CITY OF TAYLOR, TEXAS

PLANNING AND ZONING COMMISSION MEETING

February 09, 2021, 6:00 P.M.

Staff has completed its review of plans for the Taylor 70 Commercial (4 Acres) Final Plat that is to be located at CR 367, Taylor 76574. Your plat will be placed on the Planning and Zoning Commission agenda for the meeting scheduled the 9th of February 2021. Comments from this review follow.

**Taylor 70
Minor Plat
Approximately 4 Acres**

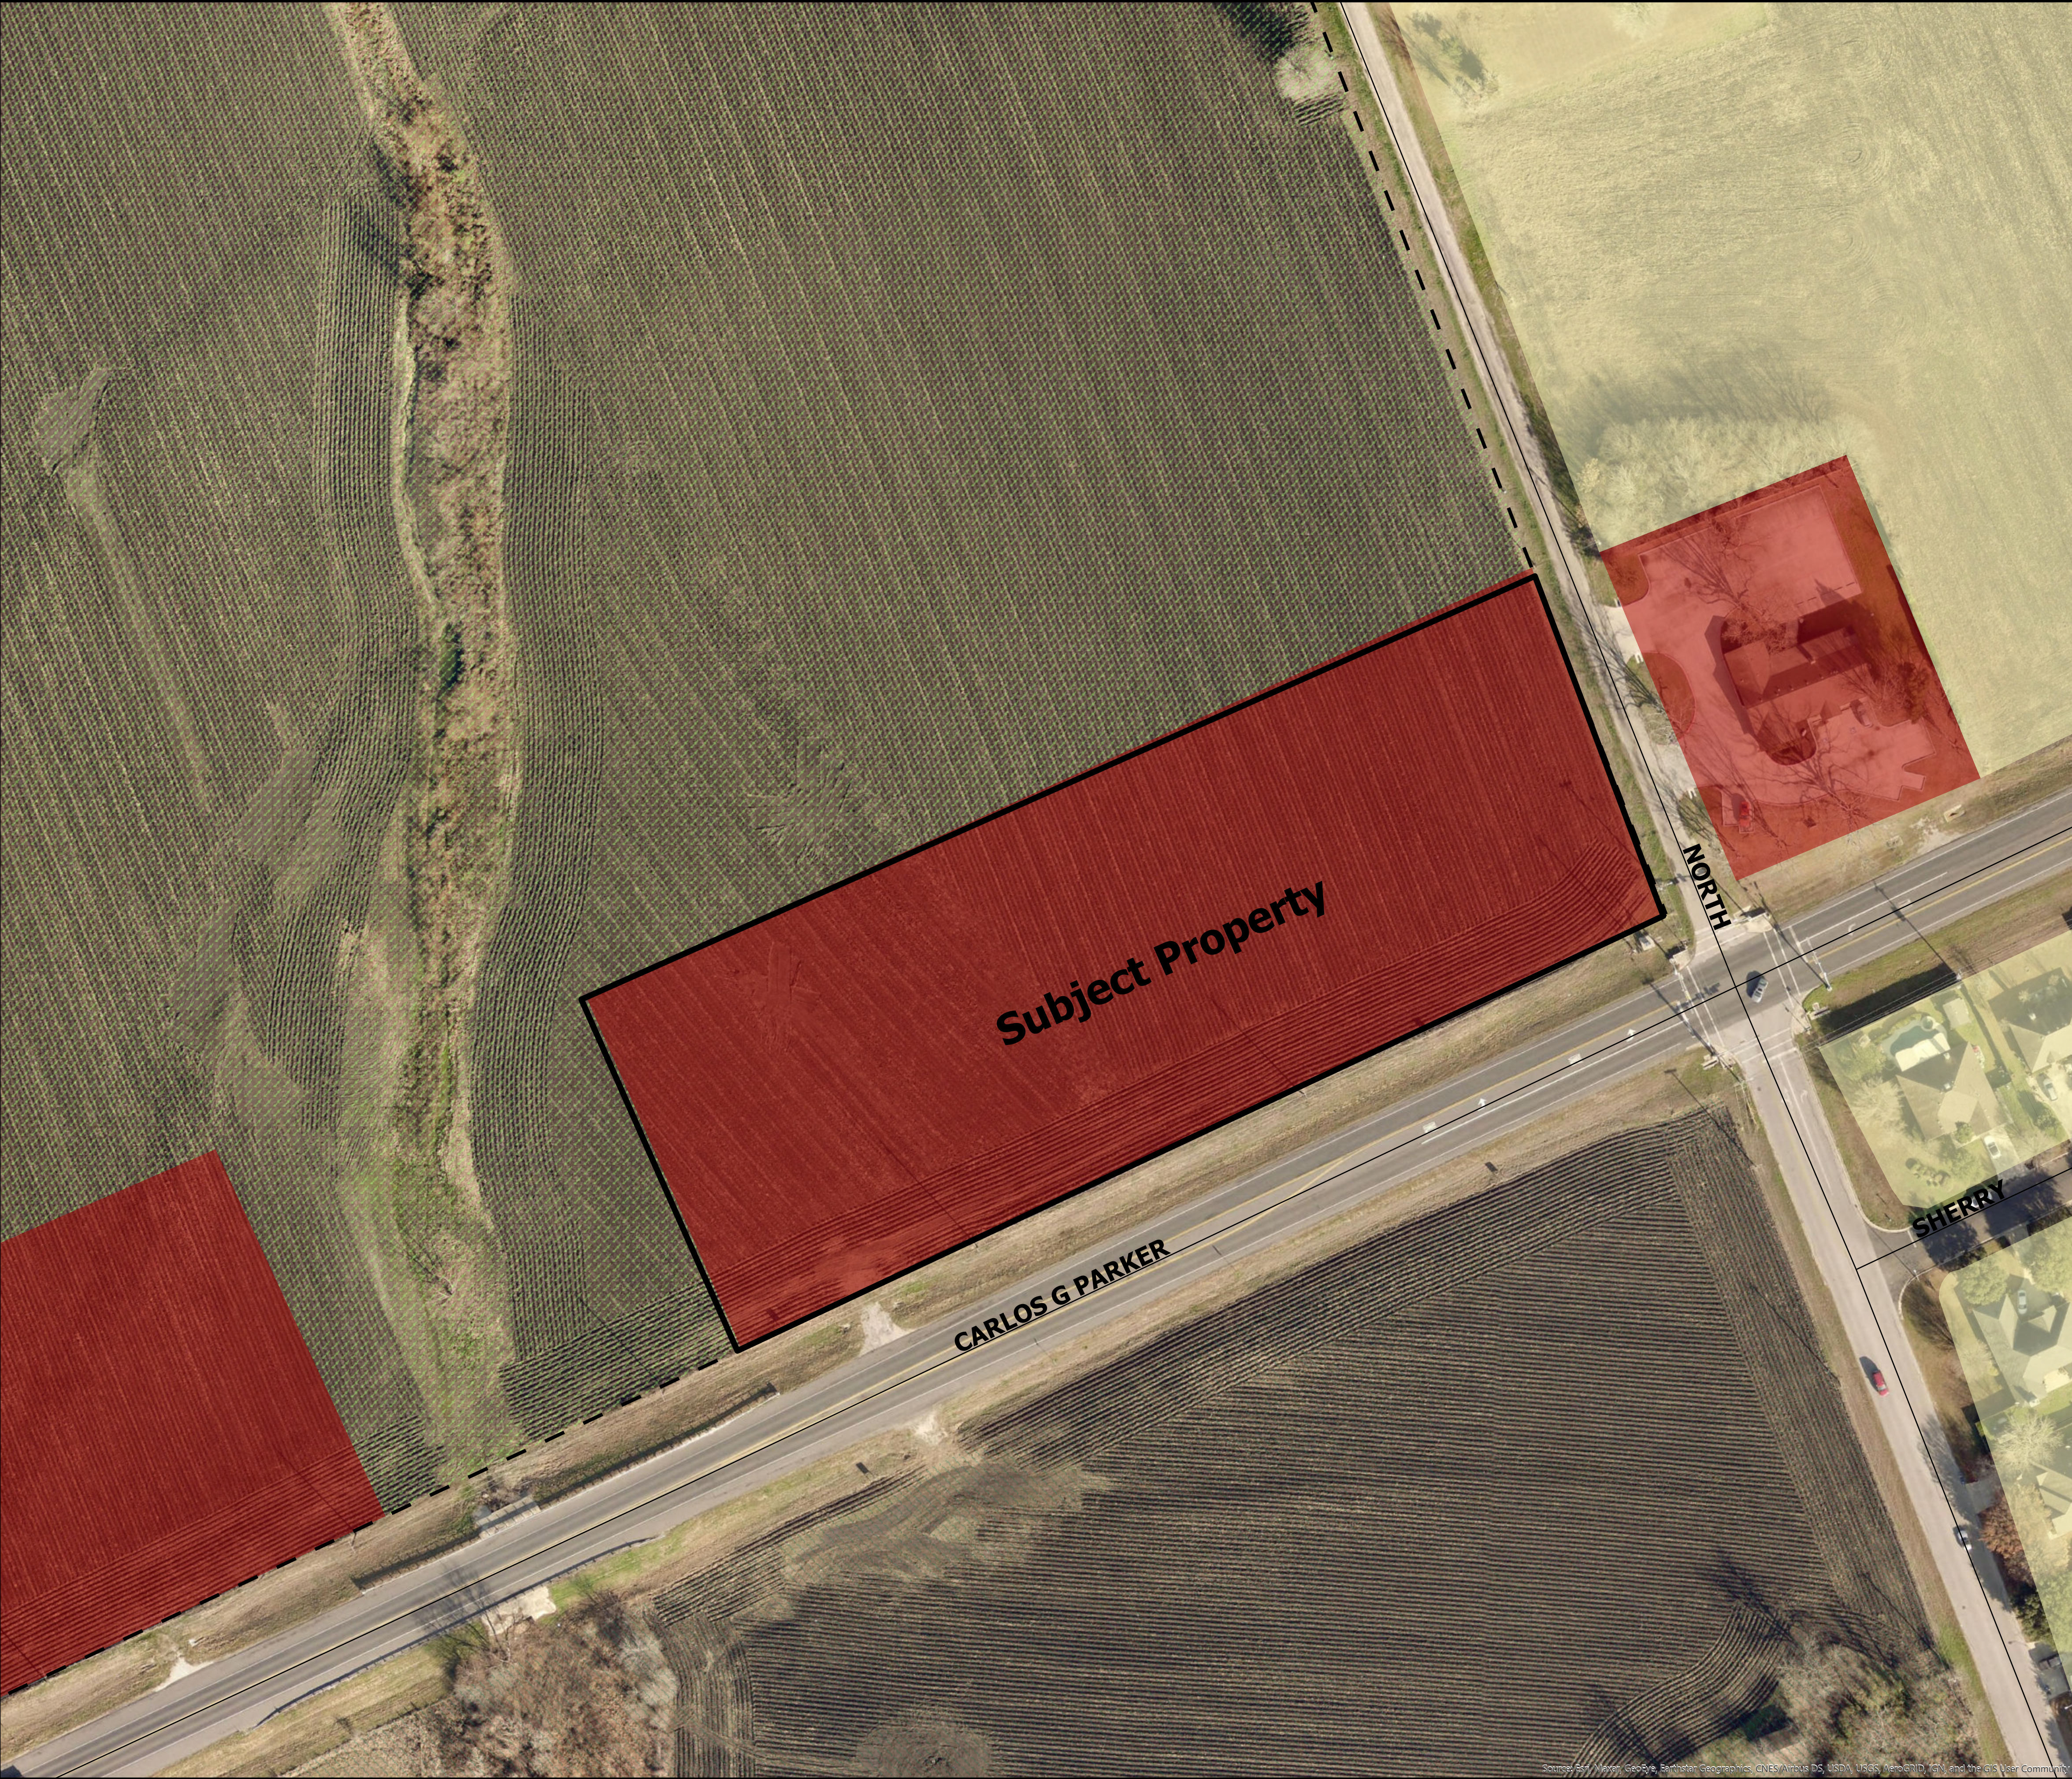
1. Show the 15-foot dedication for North Drive and correct the width of the proposed lot, which is 654.97 feet rather than 670.00.
2. This proposed lot is 4.0 acres and is part of a tract that is 27.64 acres so the remainder of the land that is owned by Mr. Slevinsky is 23.65 acres including the 7.00 acres. Correct the acreage. If you want to notate the 7.00 acres separately from the 17.65 acres of original acreage of the remainder then state that the parcel is "a 17.65 remainder tract of a called 83.47 acre tract, etc". Additionally, the ownership is an estate not an individual.

3. The land north of the remainder tract of the Slevinsky property is owned by Patricia A. Greinert (LE) so add the name to the notation.
4. RCT Holdings LLC notation has the wrong deed instrument number. The number is 2016044780. Correct the notation.

5. The property noted as owned by Seguin Affordable Homes was sold so correct the notation. The land belongs to EVK Homes LLC now.
6. The land across Carlos G. Parker changed hands last November and is now owned by Creek Bend Holdings, LLC. Correct the notation.

7. There is a 170.24-foot public utility easement missing from the north property in northeast corner of the proposed plat. Add the easement to the proposed plat.
If the sidewalks are not constructed then they need to be bonded out.

10. You do not need two Planning and Zoning Commission Certificates. Remove them. The Director of Development Services is Tom Yantis, A.I.C.P.
11. The Williamson County Clerk wants her certificate in the bottom right corner.
12. Remove the "3.5" on Carlos G. Parker Blvd. on the vicinity Map and add "Carlos G. Parker Blvd."

- i. Label point of beginning on the plat drawing.
- ii. Remove Preliminary Plat - P&Z Commission block
- iii. Verify metes and bounds course along southern property line. Distance shown does not match description notes.
- iv. Provide the course highlighted in the engineering plat review document located in the Associated Files of this permit page.
- v. Verify additional ROW dedication (approx. 15-ft) along portion shown on the plat review document for future utility extension to Taylor 70 planned development. Provide total ROW dedication in notes.
- vi. Verify control point is tied to a corner of the original tract and include a tie to the closest platted lot per the City of Taylor Plat Application Packet

Please revise the project plans to address the comments noted above. Following revision, please submit one hardcopy of the revised set for each reviewer that has outstanding comments. Please also submit one electronic copy of the revised drawings in PDF format.
